**Subject: NEXTERA BLYTHE SOLAR ENERGY CENTER LLC'S RESPONSE TO
CEC STAFF DATA REQUEST SET 1 (1-19)
BLYTHE SOLAR POWER PROJECT AMENDMENT
DOCKET NO. (09-AFC-6C)**

BLYTHE SOLAR POWER PROJECT (09-AFC-6C)

RESPONSES TO DATA REQUESTS – SET 1

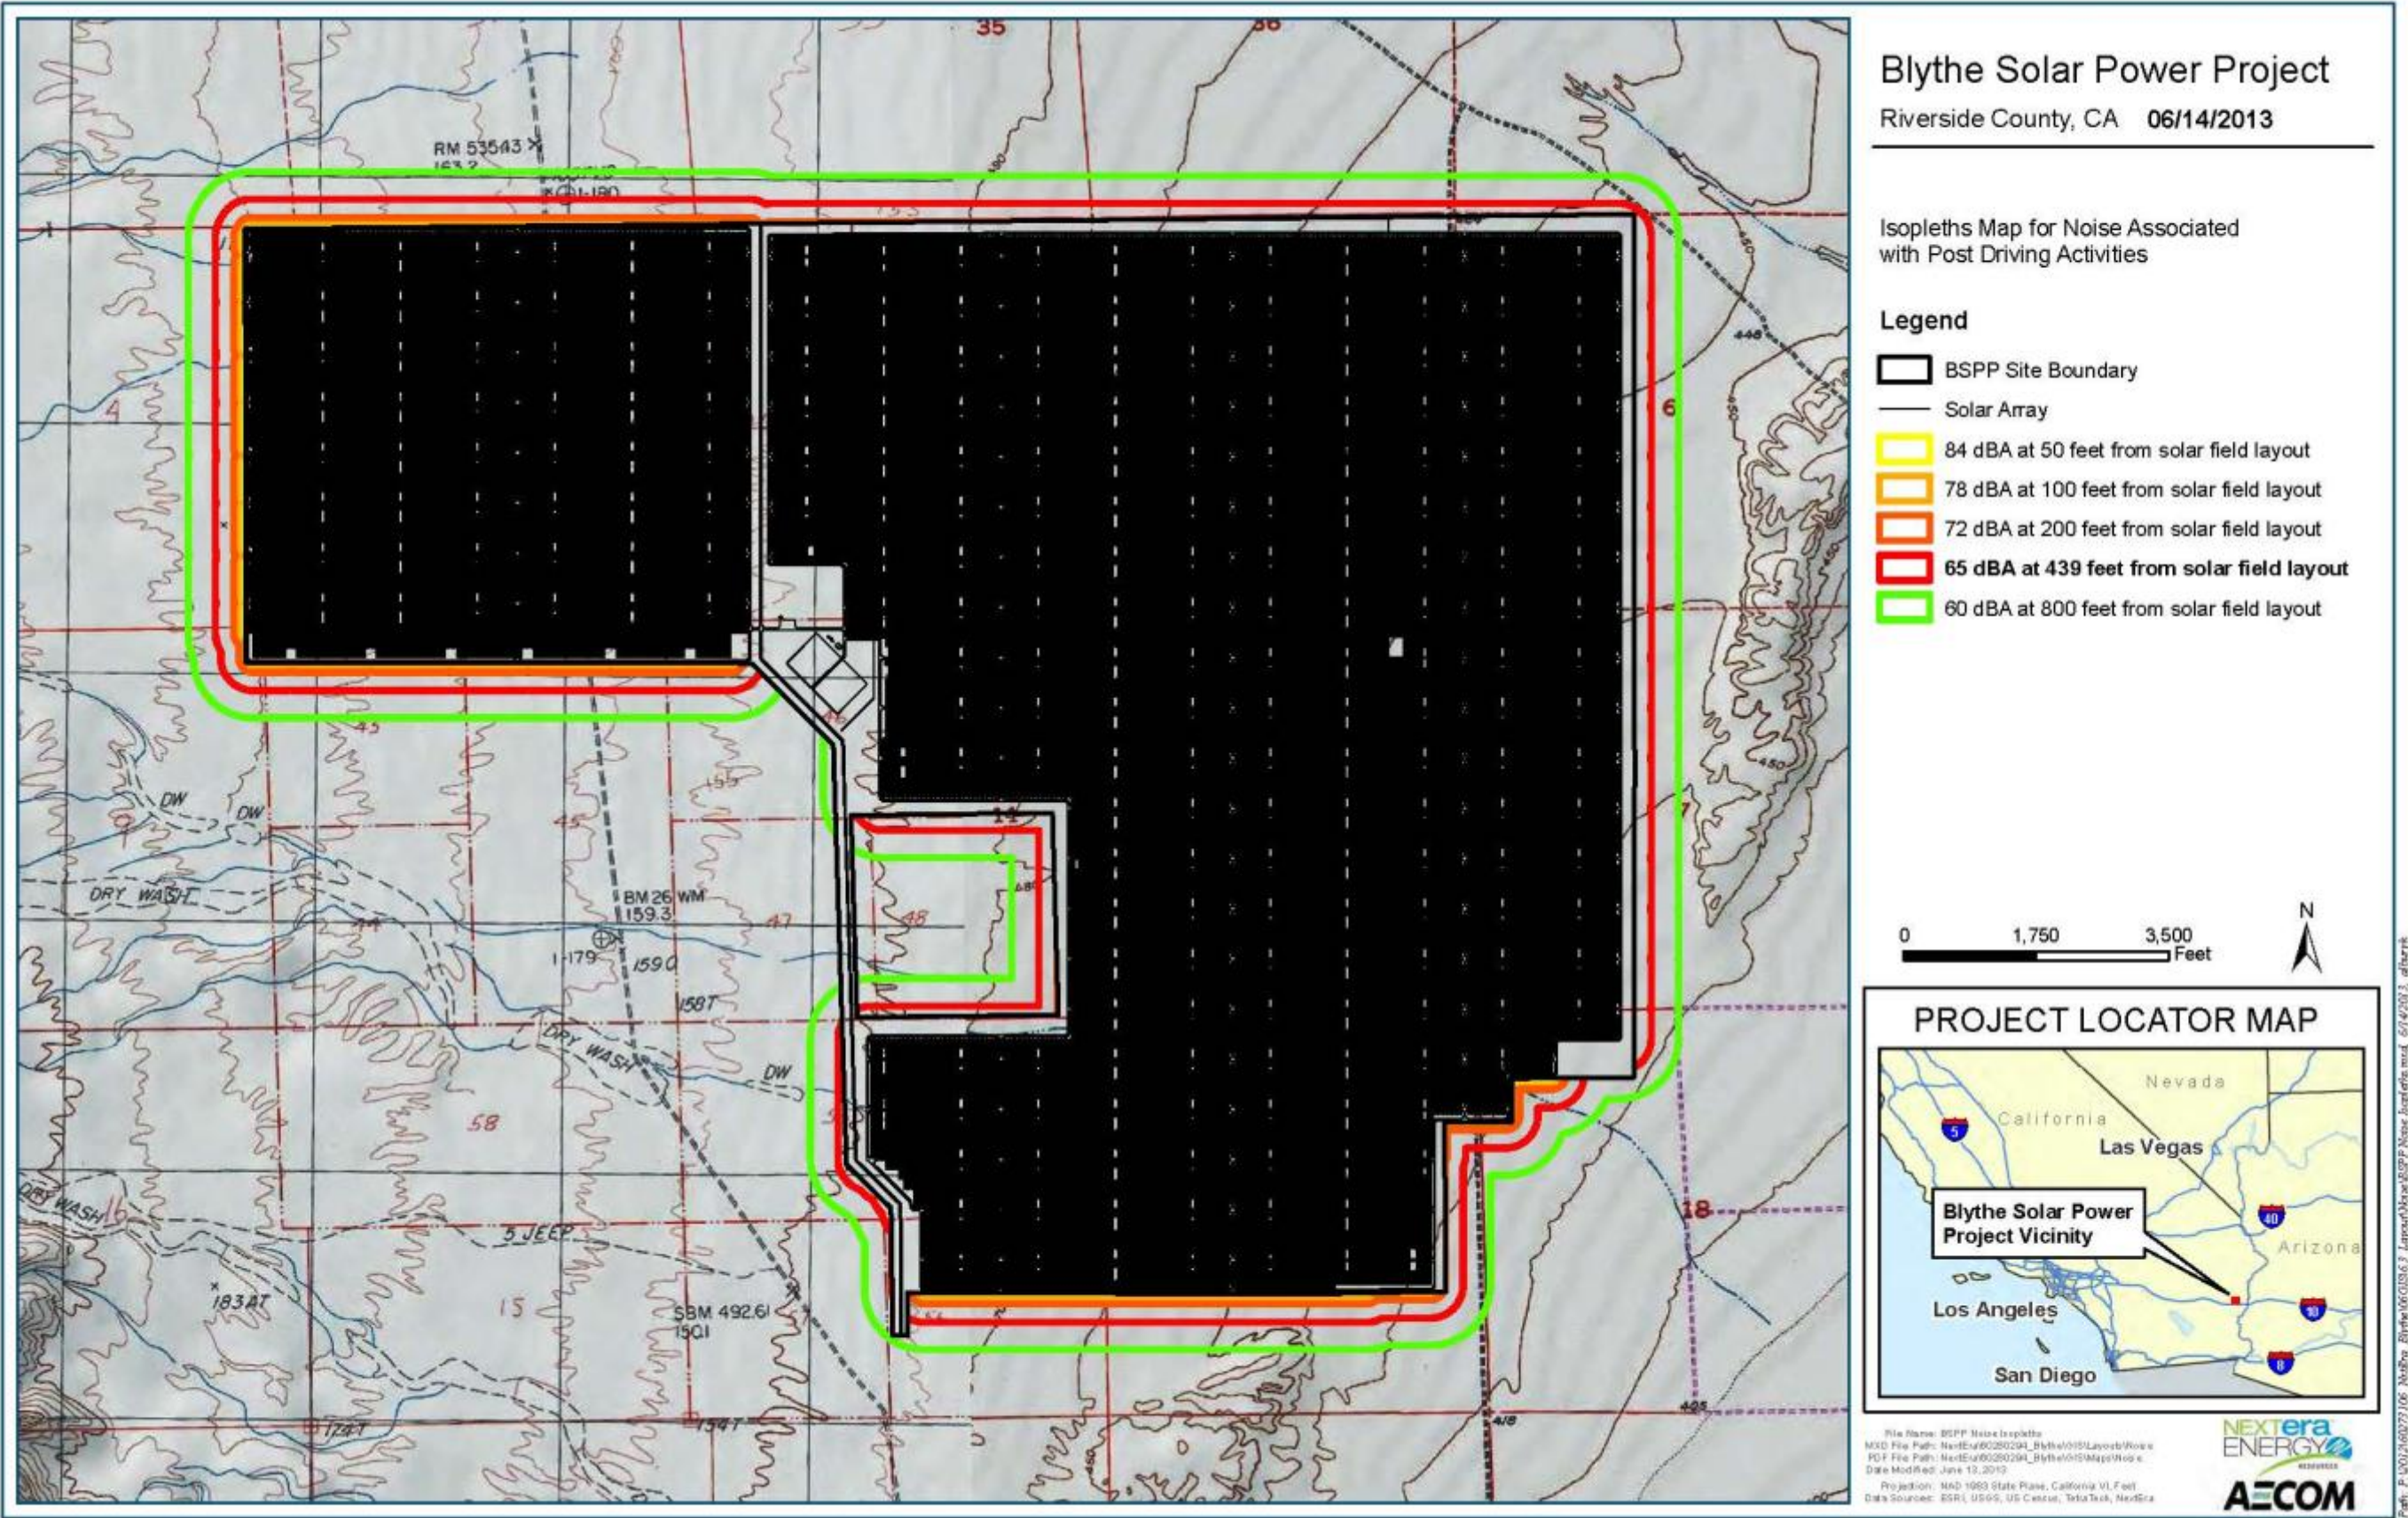
1. Noise impacts from Hydraulic Ram. Please provide an isopleths map of noise levels in decibel (dB) from a hydraulic ram operating near the project boundary to 50 feet beyond boundary and 100 feet beyond boundary or until the dB level drops to <60 dB or lower from the edge of the boundary. Please include the distance it drops below 60dB.

An isopleth map that shows the off-site noise levels from noise generated by operation of the hydraulic ram (pile driver) is provided in Attachment Data Response (DR) 1. A memorandum explaining the analysis of off-site noise from the pile driver is also provided in this Attachment. As shown on the map in Attachment DR 1, based on "worst case" assumptions for maximum noise levels and the location of pile driver use on photovoltaic (PV) panel posts near the property boundary, noise from the pile driver attenuates to 60 dB or below at a distance of approximately 800 feet from the edge of the solar layout near the project boundary.

ATTACHMENT DR 2
MAP OF SPECIAL STATUS PLANTS

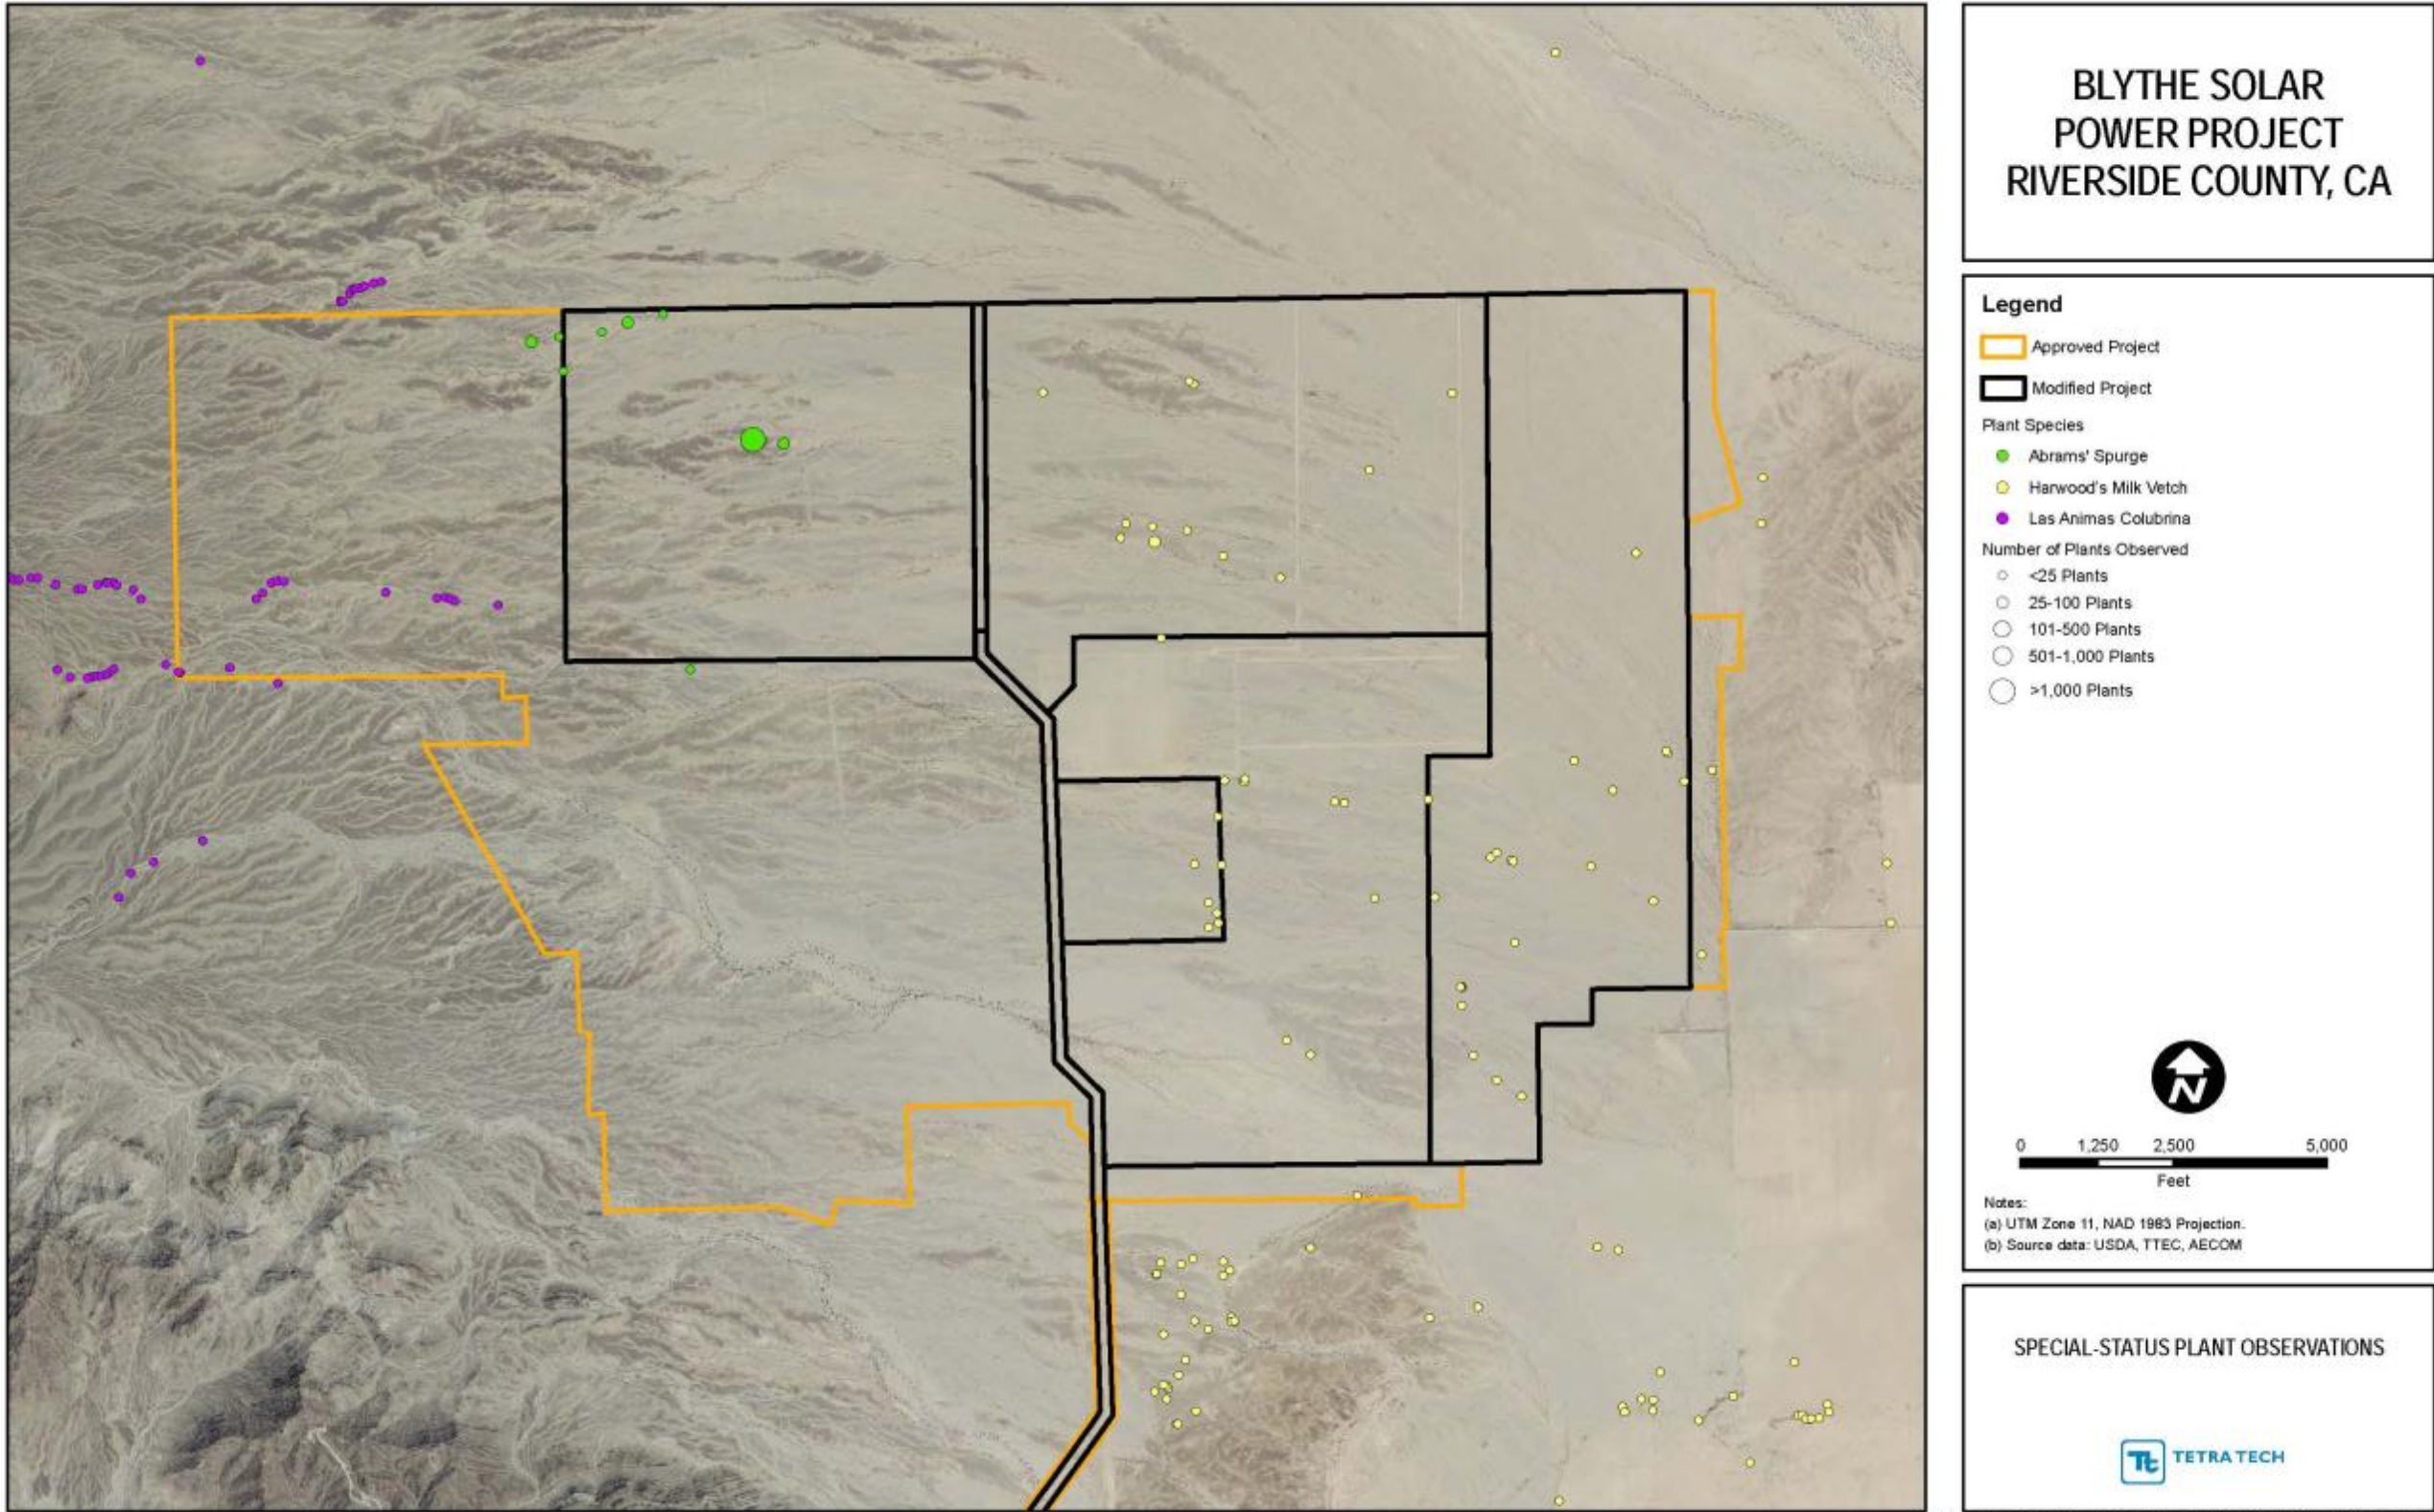
2. Map of Special-Status Plants. Please provide a figure of the approved project with an overlay of the modified project boundaries and include locations of Las animas colubrina, Harwood's milk-vetch, and Abrams' spurge. Please also provide the electronic files for all known special-status plant locations as shape or geodatabase files.

Attachment DR 2 provides the requested information. A compact disc (CD) containing the geographic information system (GIS) files has been provided with this Data Response.
